ATTACHMENT 1 TO AEP:NRG:1146
10 CFR 50.92 ANALYSIS FOR CHANGES TO
THE DONALD C. COOK NUCLEAR PLANT
UNITS 1 AND 2
TECHNICAL SPECIFICATIONS

EXISTING TECHNICAL SPECIFICATIONS
PAGES MARKED TO REFLECT PROPOSED CHANGES

PROPOSED REVISED TECHNICAL SPECIFICATION PAGES

Figure 5.6-1: Donald C. Cook Nuclear Plant Schematic for Fuel Storage Racks Interface Boundary Between Regions 1 and 2

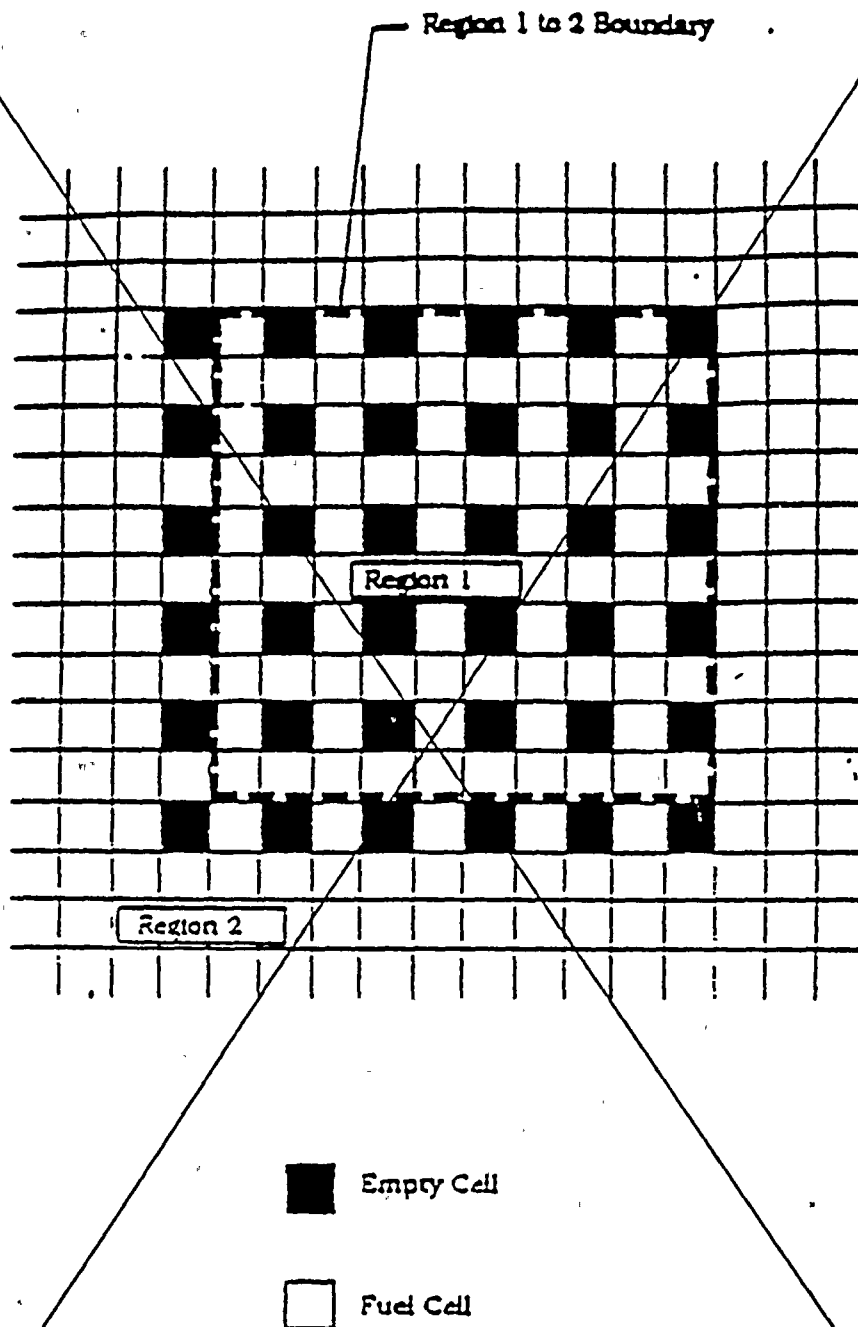
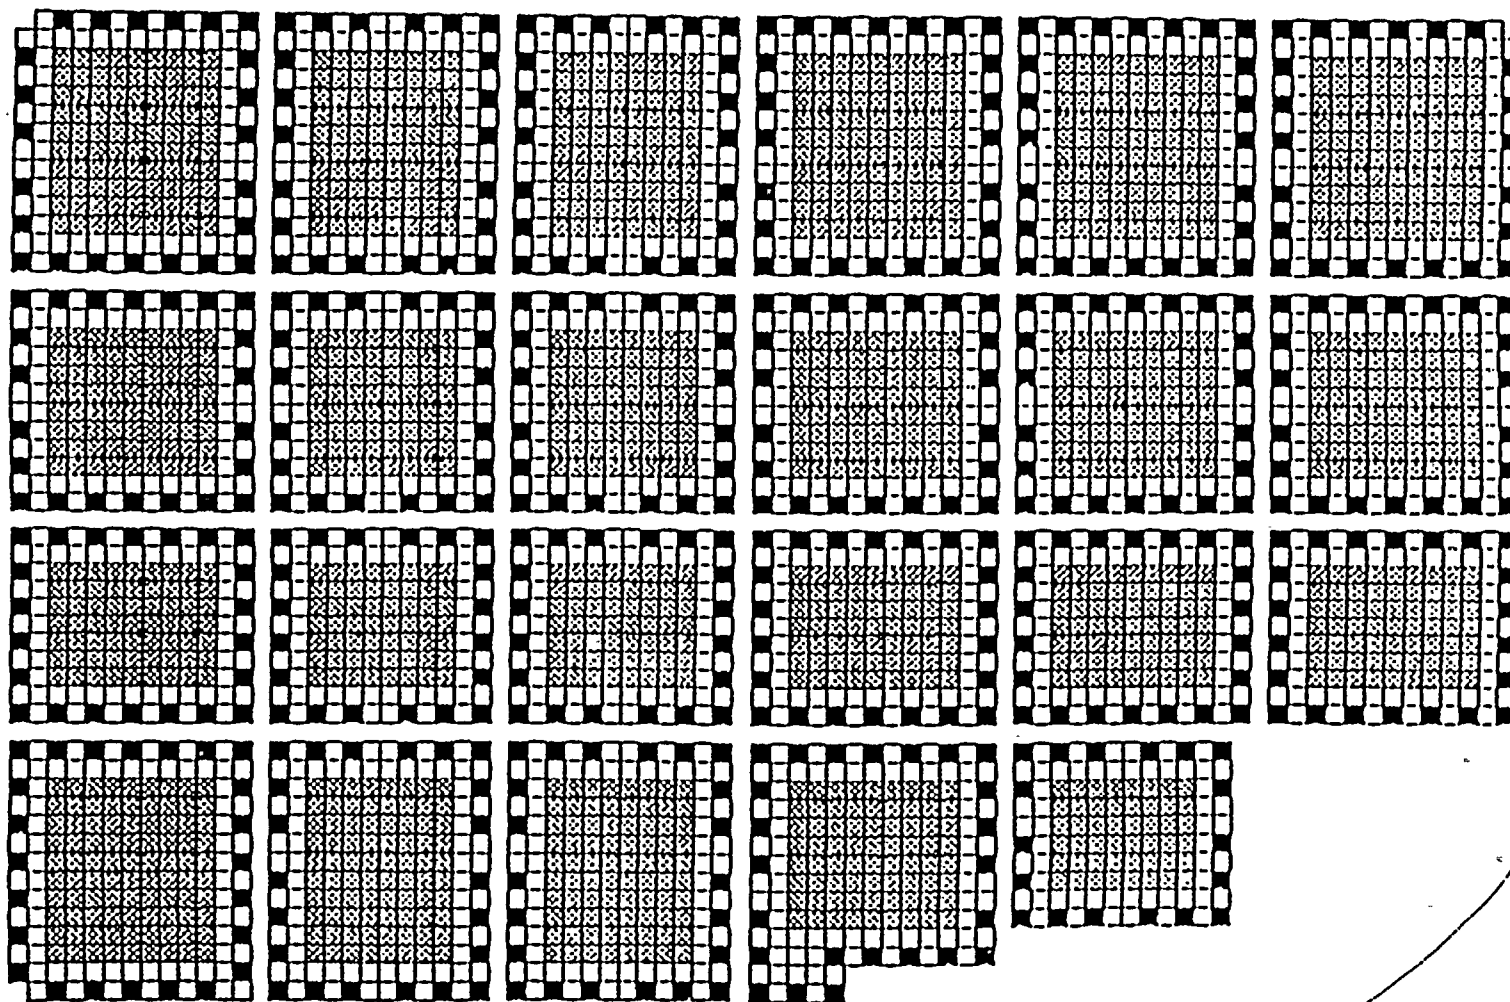
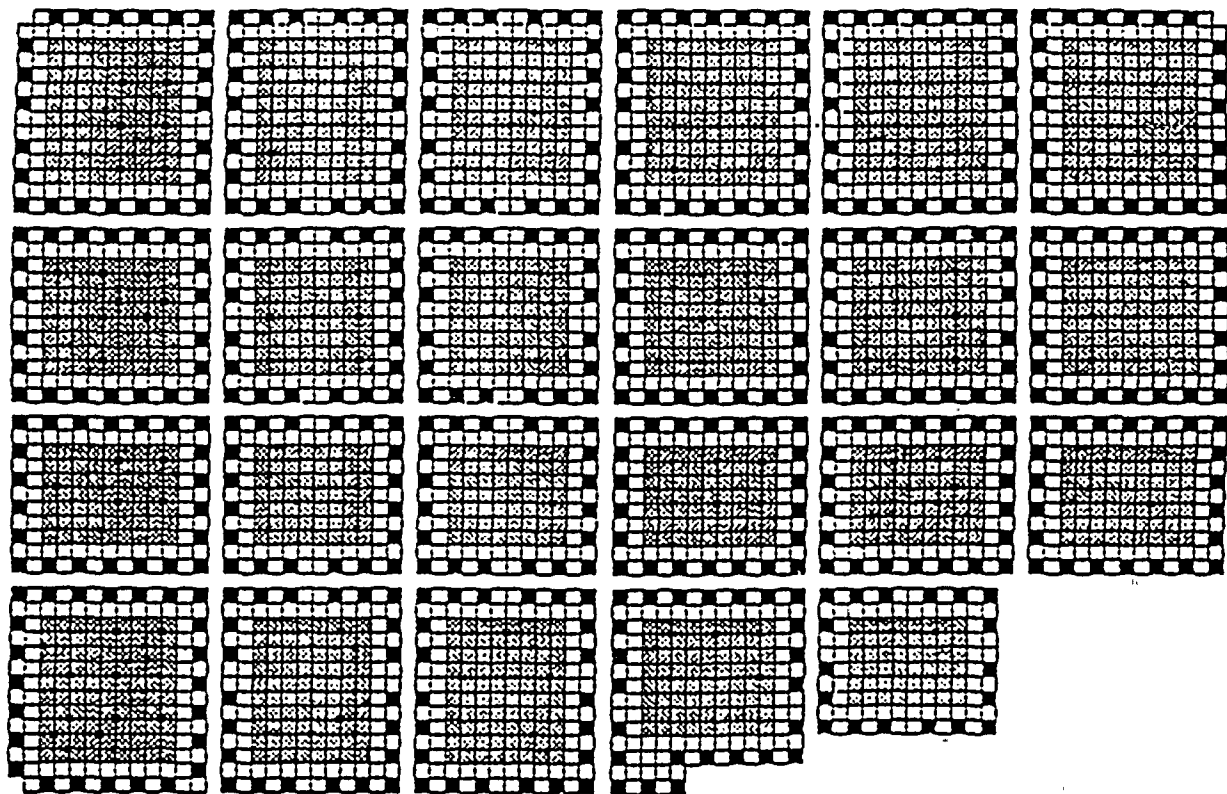
- #4. The nominal center-to-center distance between fuel assemblies placed in the storage racks is decreased from 10.5 inches to 8.97 inches.
- #5, The current storage configuration restrictions for storage of Westinghouse fuel with nominal enrichment greater than 3.95 weight percent U-235 and burnup less than 5,550 MWD/MTU are superseded. The present 2 regions are replaced with 3 regions. The definitions of the regions are no longer dependent on fuel vendor (Westinghouse vs. Exxon/ANF.) Two options for storage patterns are provided as Figures 5.6-1 and 5.6-2 of the proposed T/S. A graphical representation of the regional definitions is provided as Figure 5.6-3 of the proposed T/S.

- #5. The present T/S establishes limits on acceptable storage locations for Westinghouse fuel with nominal enrichment above 3.95 wt% U-235 and with burnup less than 5,550 MWD/MTU. Storage of assemblies meeting these requirements must be in a checkerboard configuration. We are proposing to supersede these requirements with new requirements that are consistent with the criticality analyses presented in Chapter 4 of the Holtec report. Three "regions" of fuel are defined. The regions are determined on the basis of burnup and initial assembly enrichment. (Ref: Section 4.2 of the Holtec report.) Proposed T/S Figure 5.6-3 includes a graphical depiction of the 3 regions. Two fuel assembly layout schemes are included in the proposed T/Ss, as Figures 5.6-1 and 5.6-2. The first is a scheme whereby all cells can be filled. A second scheme is included which more easily facilitates a full core off-load. This scheme is considered an "interim" scheme, which may be used before the pool is approaching its full capacity. These two loading schemes are discussed in Section 4.2 of the Holtec report. Loading of assemblies into either scheme will be administratively controlled by Cook Nuclear Plant Procedures.

~~2. The boundary between the Region 1 mentioned above and the rest of the spent fuel storage racks (defined as Region 2) shall be such that the three-out-of-four storage requirement shall be carried into Region 2 by, at least, one row as shown in figure 5.6-1.~~

FIGURE 5.6-1: Normal Storage Pattern (Mixed Three Zone)

Figure 5.6-2 -

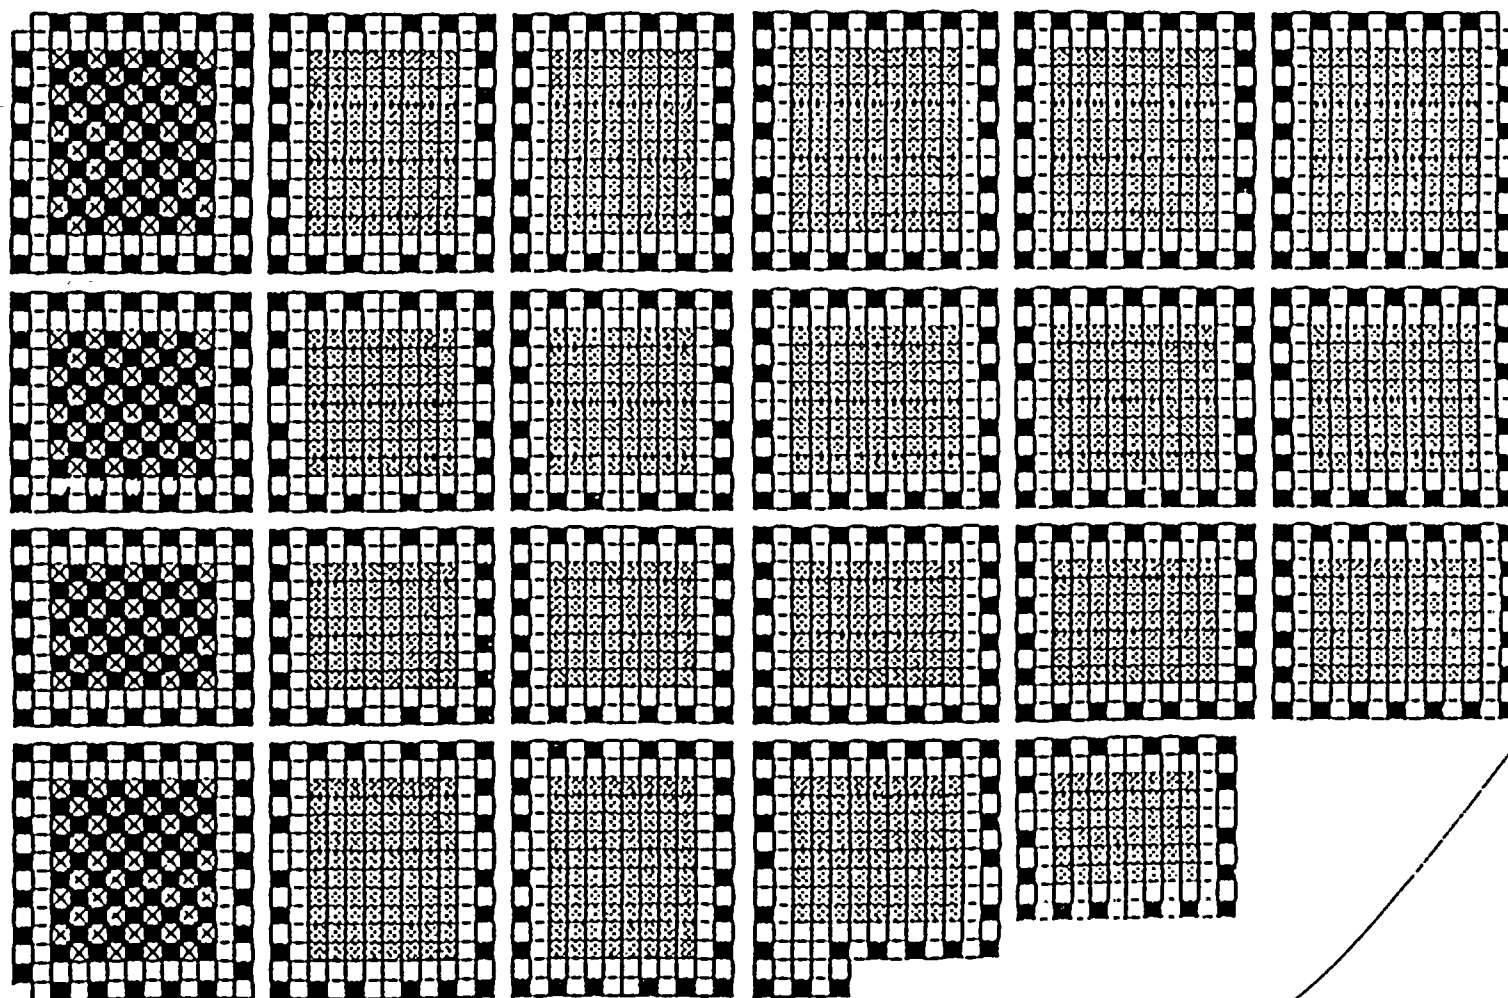
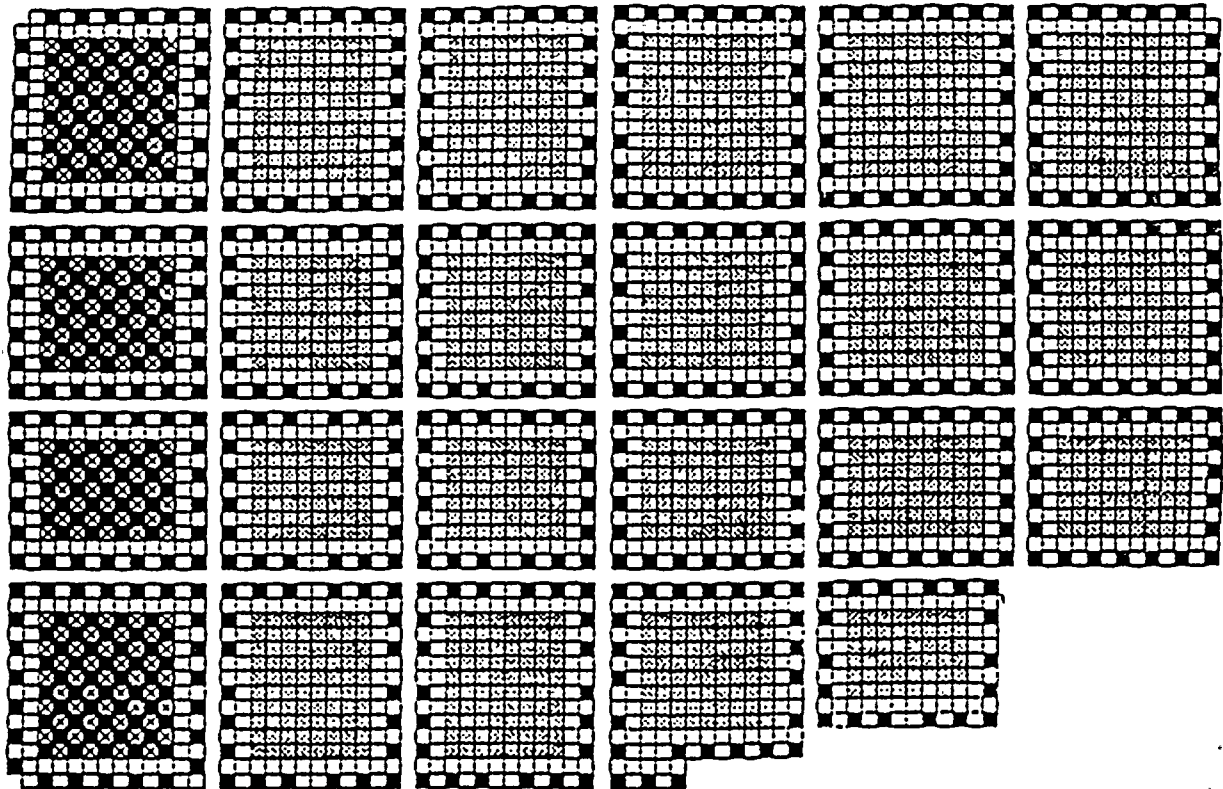
- #6. The current storage configuration restrictions for storage of Westinghouse fuel with nominal enrichment greater than 3.95 weight percent U-235 and burnup less than 5,550 MWD/MTU are superseded. The present 2 regions are replaced with 3 regions. The definitions of the regions are no longer dependent on fuel vendor (Westinghouse vs. Exxon/ANF.) Two options for storage patterns are provided as Figures 5.6-1 and 5.6-2 of the proposed T/S. A graphical representation of the regional definitions is provided as Figure 5.6-3 of the proposed T/S.

Figure 5.6-2: Interim Storage Pattern (Checkerboard)

Fig. 4-3 ACCEPTABLE BURNUP DOMAIN IN REGIONS 2 & 3

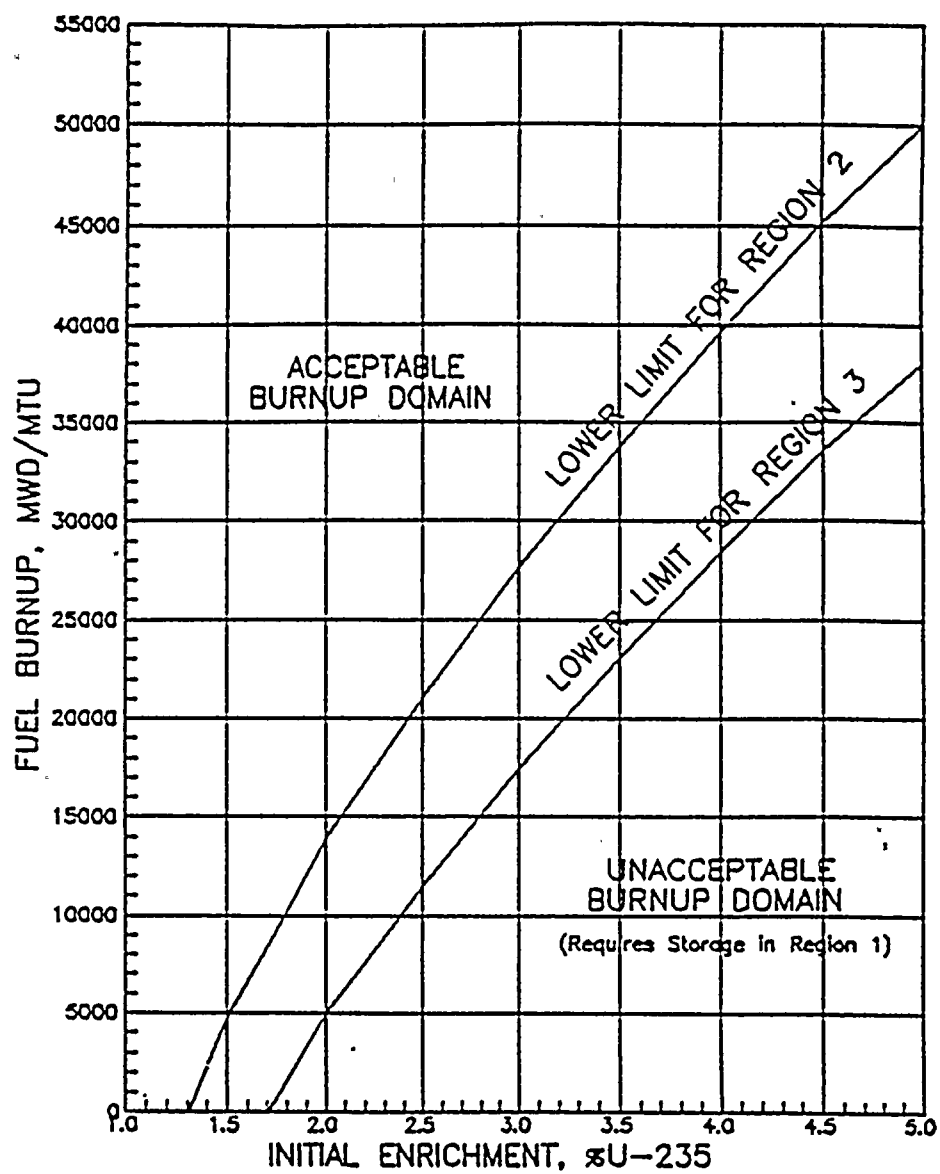
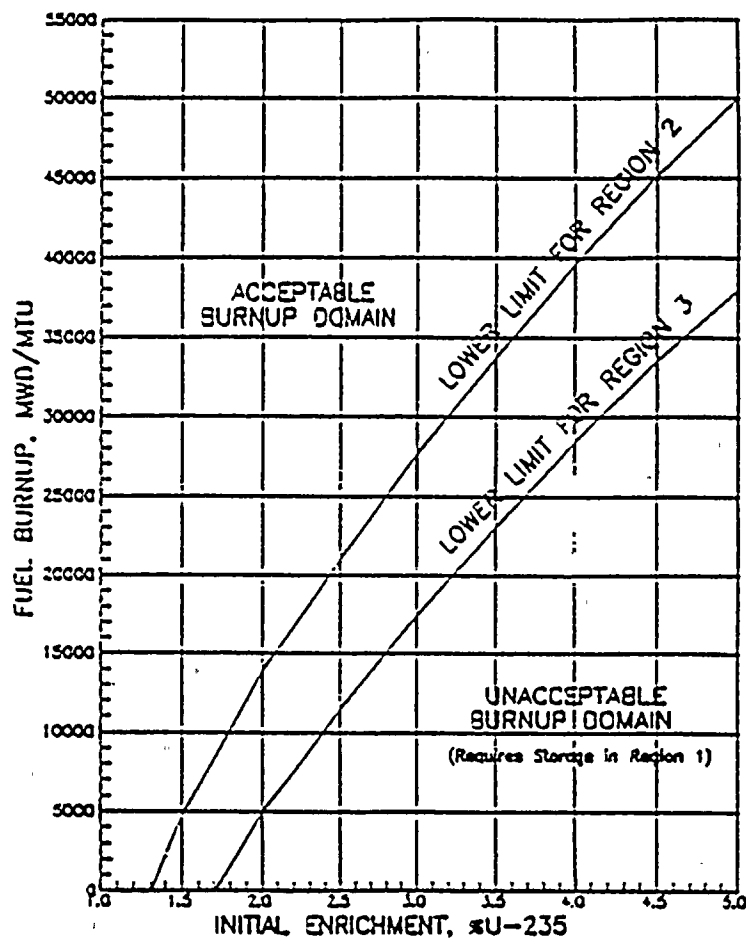
The equivalent reactivity criteria for Region 2 and Region 3 is defined via the following equations and ~~are~~ graphically depicted in figure 5.6-3.

Figure 5.6-3: Acceptable Burnup Domain in Regions 2 & 3
